PLAN-021615

Proposal: Demolition of garage. Two storey side extension & single storey rear extension.

Site: 10 Harefield Road, Middleton-on-Sea, PO22 6EB.

M/5/18/HH

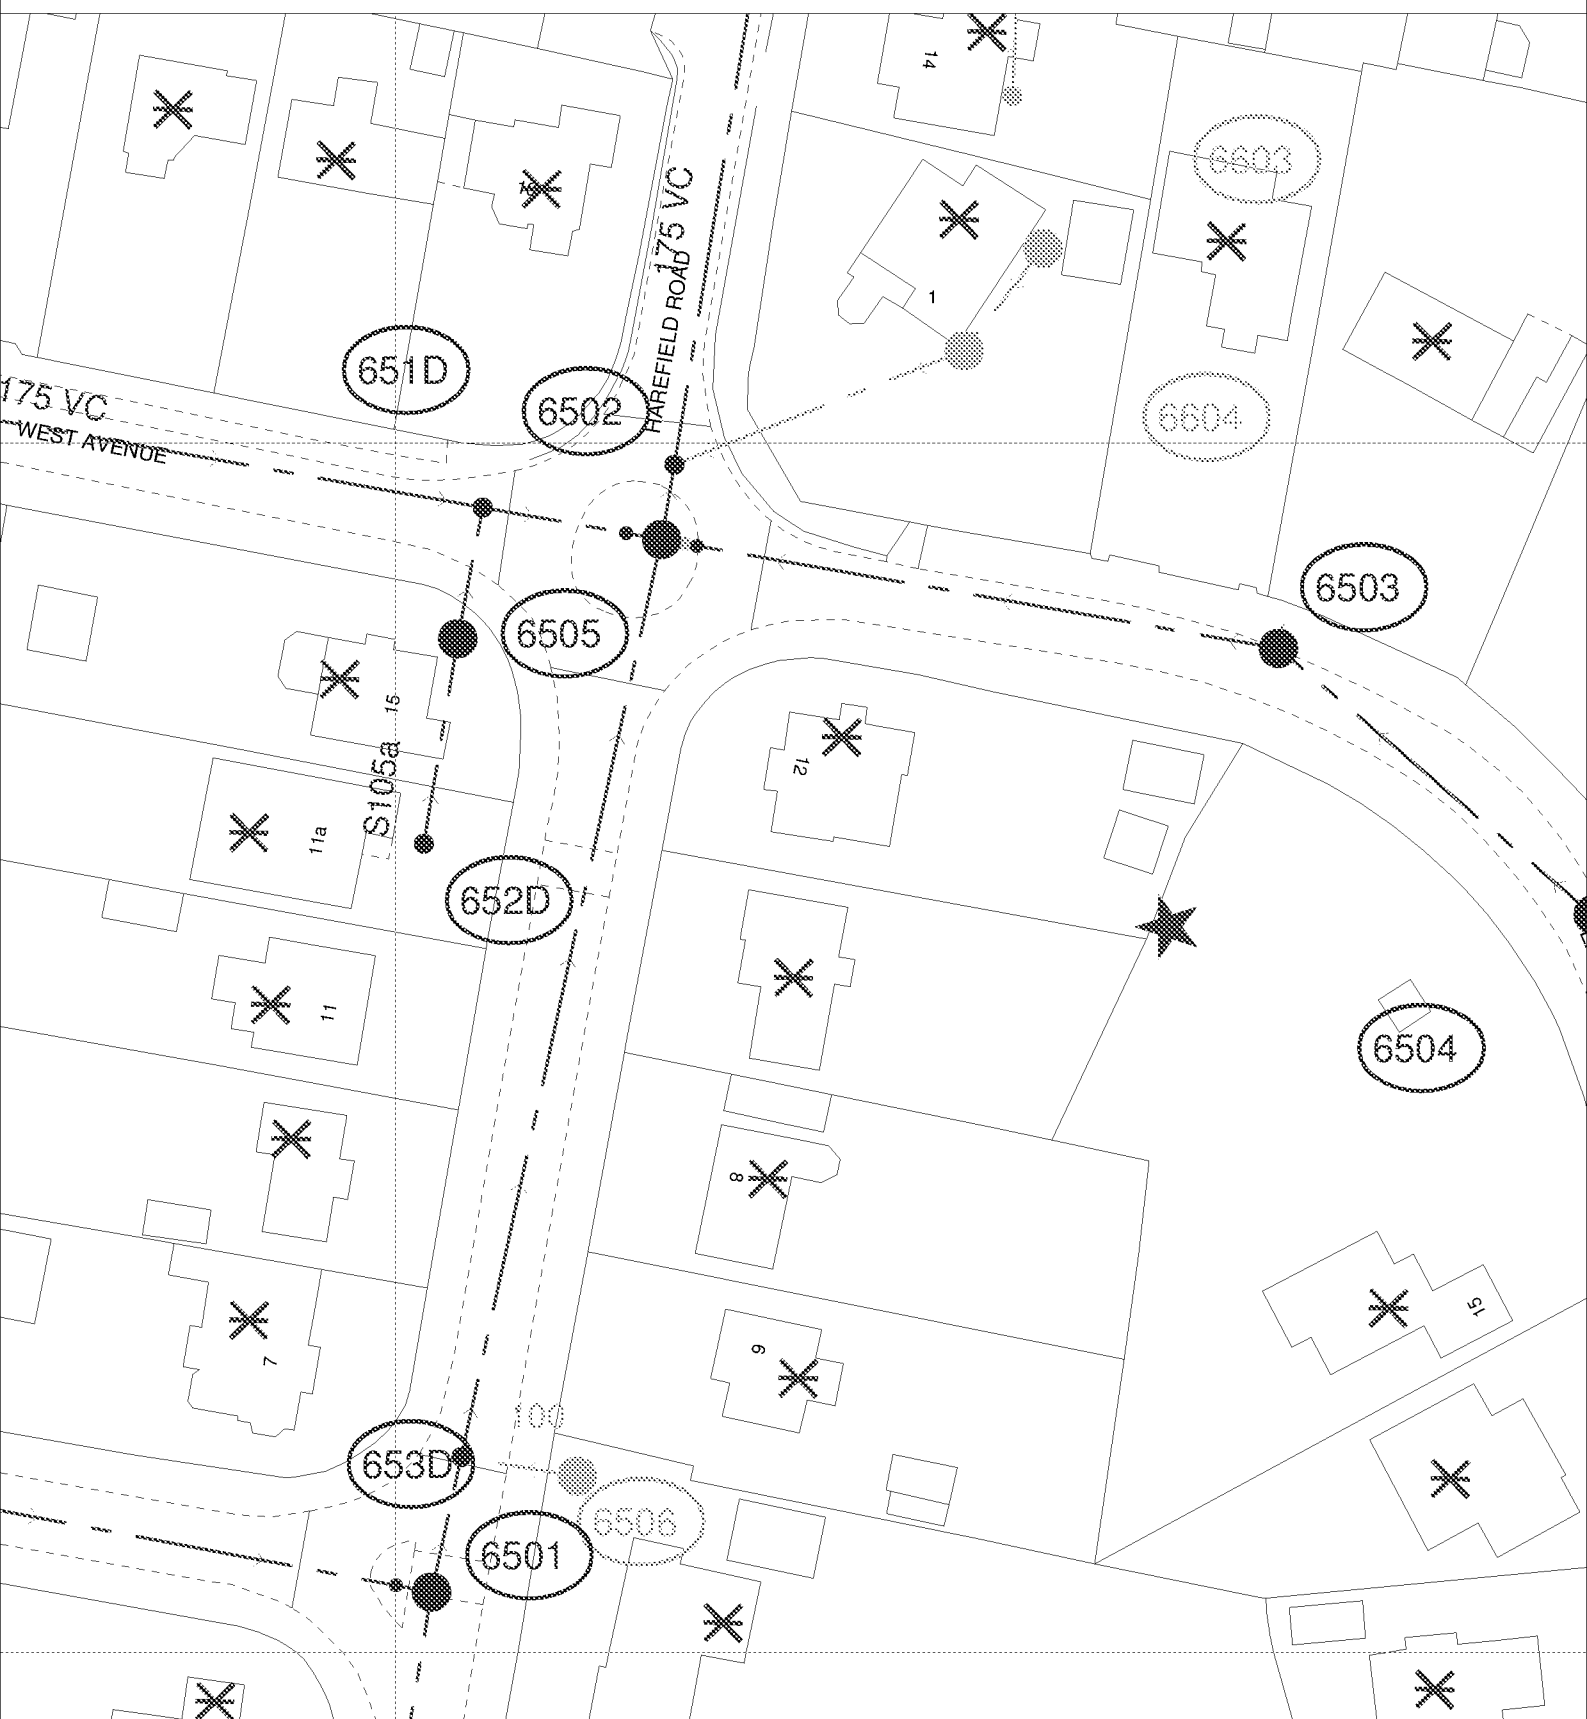
Due to surface water inundation issues in the Lidsey Catchment "The applicant is advised to adopt, where appropriate, the measures in the table "Practical measures to reduce the potential impacts of development".

Developer should look to protect the public sewerage system from inundation and infiltration, which contribute to flooding in unfavourable conditions.
